January 30, 2006

Project Texas Roadhouse Madison, WI  
Project # 20050922.2  
Re Resubmittal: Urban Design Review

Please note the following revisions to the documents listed above:

**WI-50922A5**  
SHEET 1 of 2

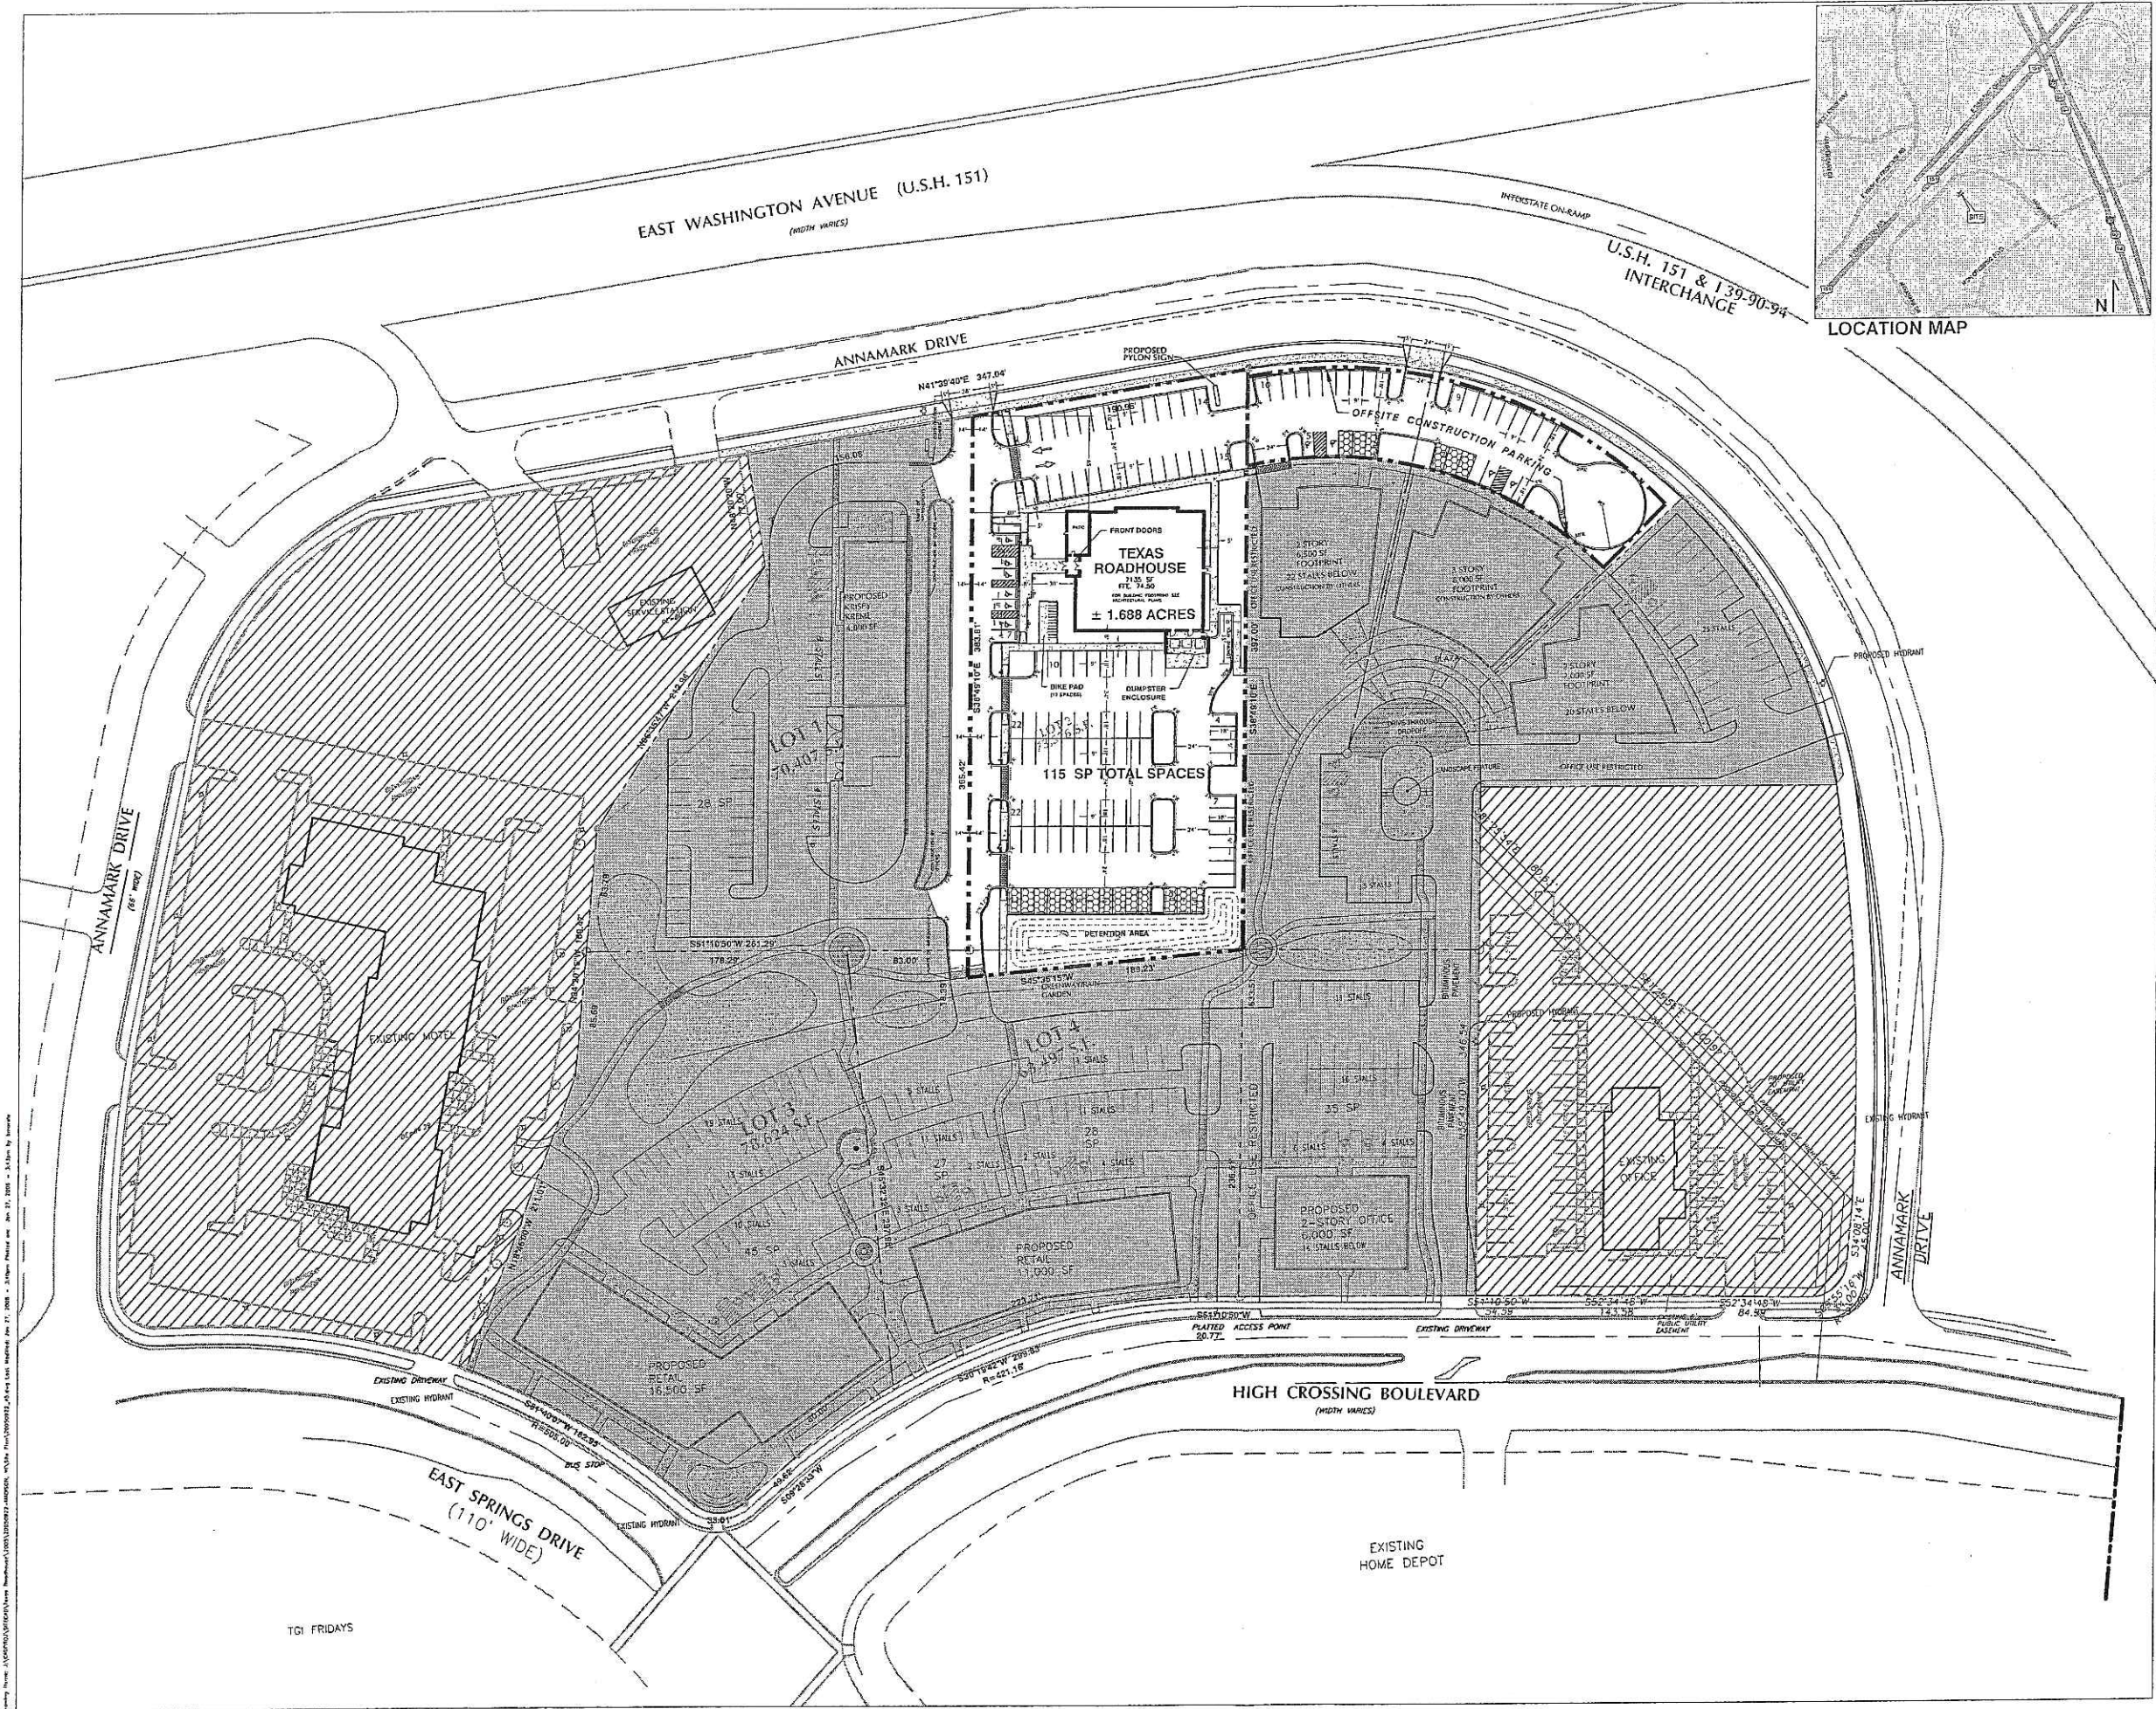
5. The site plan has been revised to add permeable pavement for the fourteen (14) parking stalls by the detention area and six (6) spaces in the off-site parking area.

SITE LIGHTING PLAN

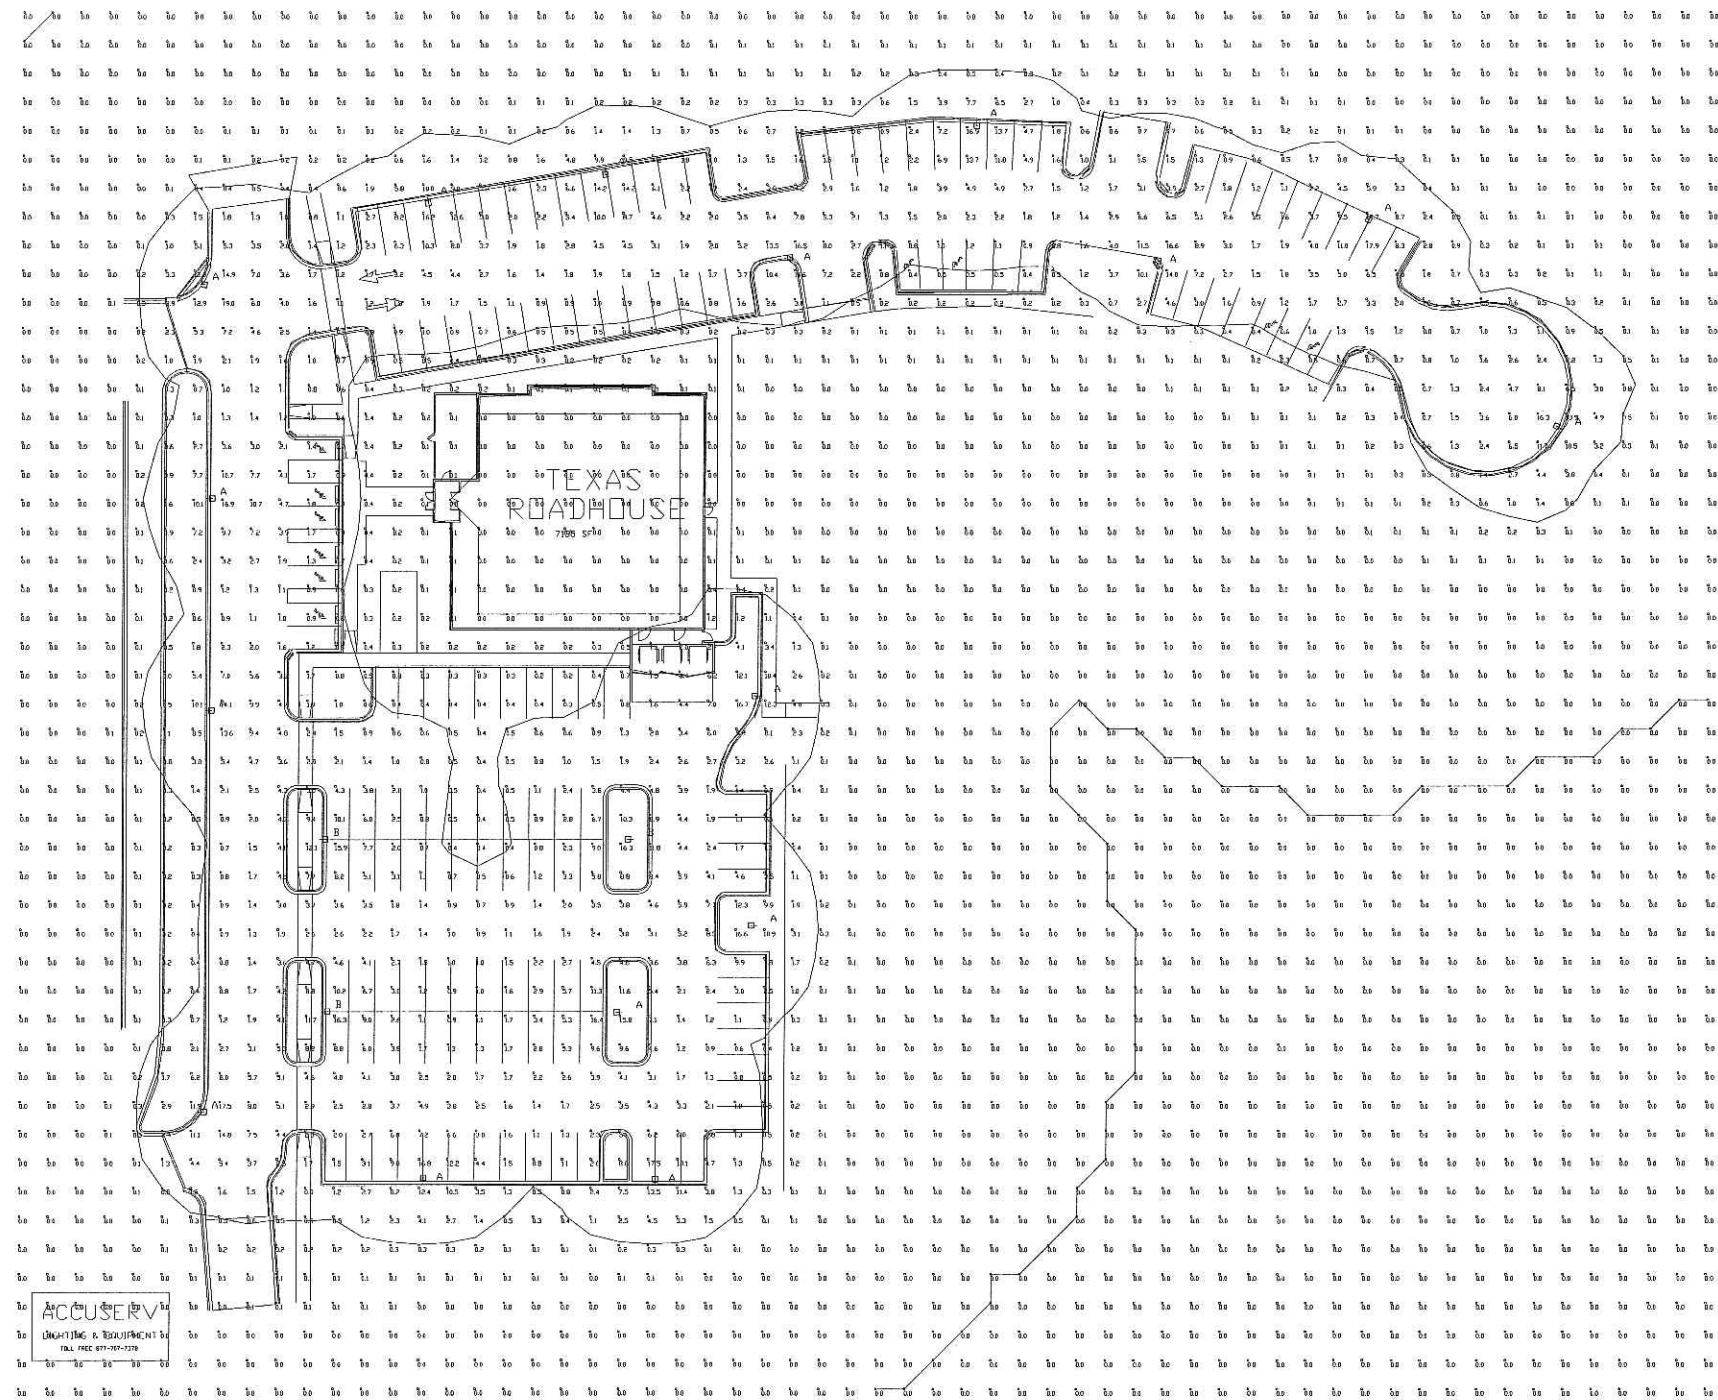
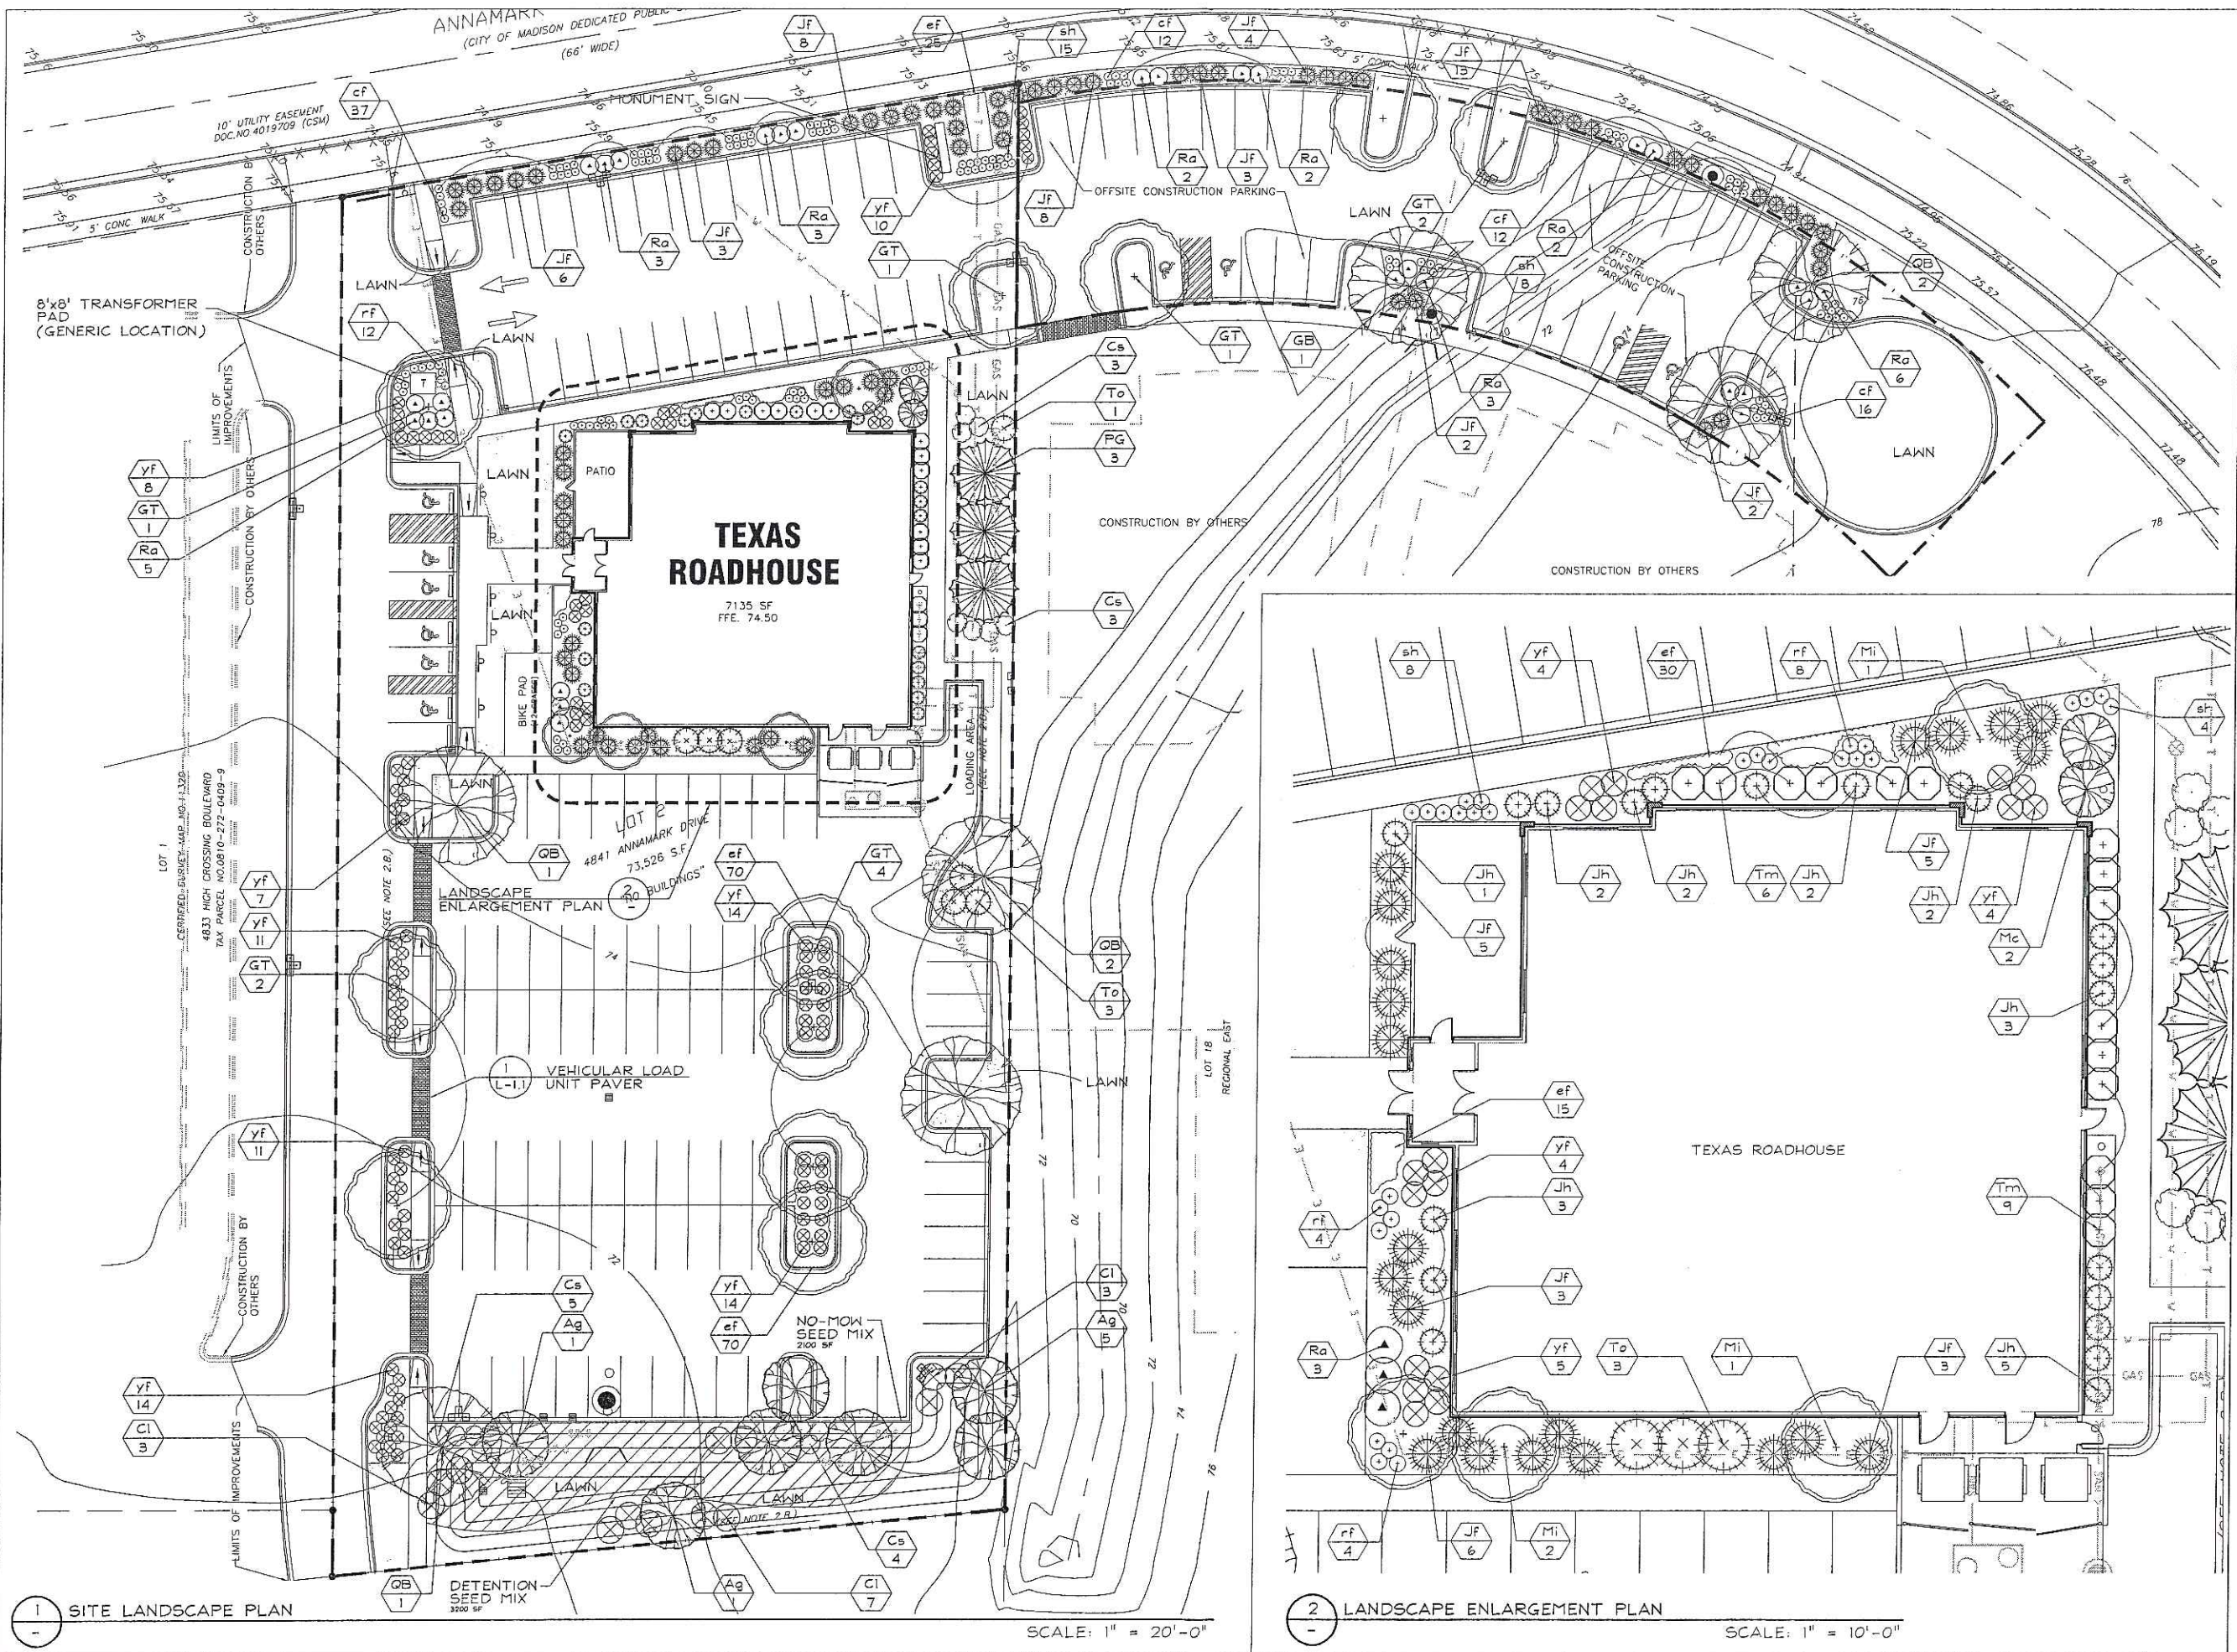
1. The photometric plan (Sheets C7.0 & C7.1 of the Civil Engineering Plan Set) has been revised to reduce the overall site lighting height from 27.5 ft. to 22.5 ft. (20' pole plus 2.5' base). Light levels have been adjusted accordingly and are more uniform throughout the site, thus reducing "hot spots."
2. Building exterior lighting has been revised to:
  - Eliminate the floodlights that up-light the roof and flags.
  - Eliminate the LED stripe that outlines the building.
3. Remaining building exterior lighting is as follows:
  - 100-175 watt MH wall packs at emergency exits (Cut Sheet "Type F12").

OPTION  
 LANDSCAPE  
 LAYOUT PLAN

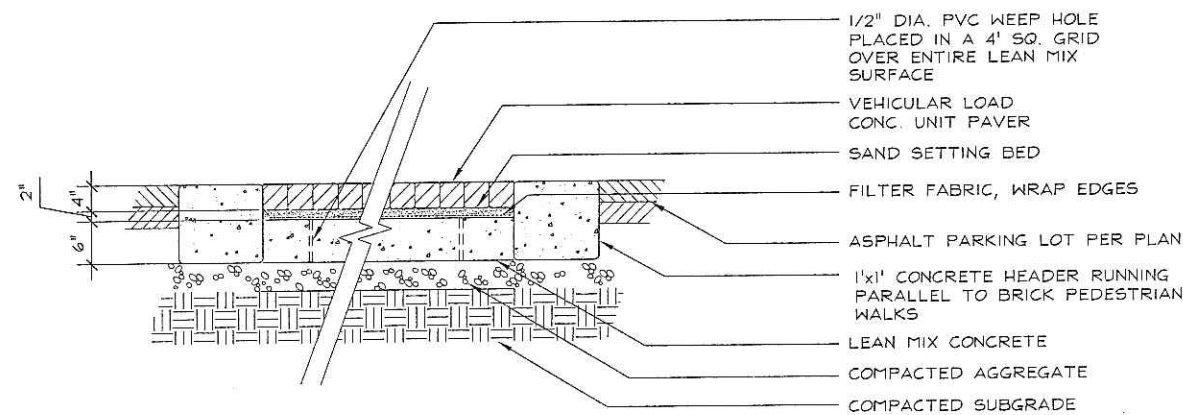
6. The landscape plan has been revised to show additional plant material in the off-site parking area and a "detention mix" proposed in the detention basin area at the southern end of the site.
